Memo

To: Board of Managers
From: Michael Younes, Director of Municipal Operations *my*
CC: Shana R. Davis-Cook, Village Manager
Date: 7/5/2013
Re: Village Sidewalk Replacements

— STANDARD FLEXIBLE BASE INSTALLATION

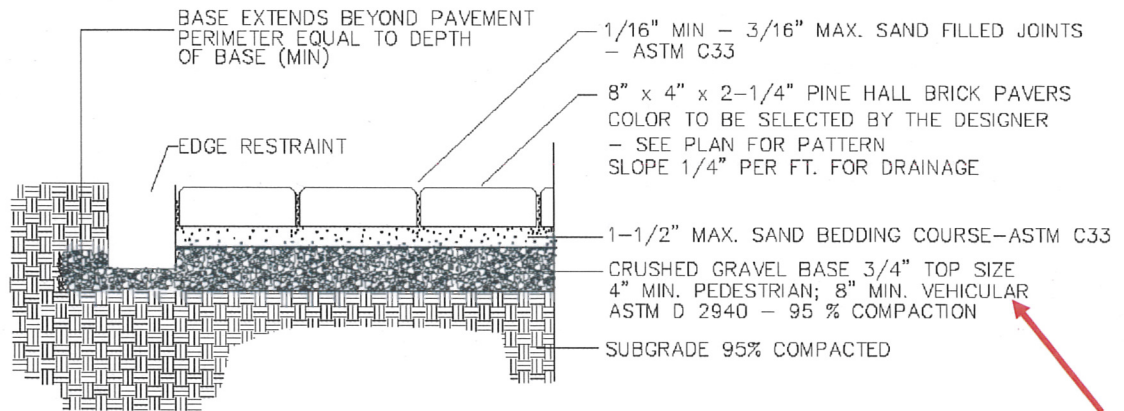
The original detail for base material of a sidewalk as it crosses a driveway calls for eight (8) inches of compacted CR-6 stone. This construction detail was designed to withstand non-commercial traffic driving across the sidewalk and a non-static load which is referred to as "light vehicular traffic". The design standard for light vehicular traffic was the direction provided to the engineer to by the Village's previous administration.

Based on my conversations with the engineering firm, they confirmed that sidewalk detail/specification was not designed to withstand heavy vehicular traffic loads. They also recommend that for added long-term durability a concrete base be used where vehicular loads are present.

For the Board's reference I have included a construction detail from the brick manufacture below which outlines a minimum 4-inch aggregate base for pedestrian traffic and 8-inch aggregate base for vehicular traffic.

- c) Modify existing sidewalk base material going forward: In lieu of using a CR-6 base, a concrete base of the appropriate thickness would be

substituted; this base will be stronger than the CR-6 and will support heavier vehicle loads on the sidewalk. The bricks would then be installed on top of the concrete base using a sand setting bed.
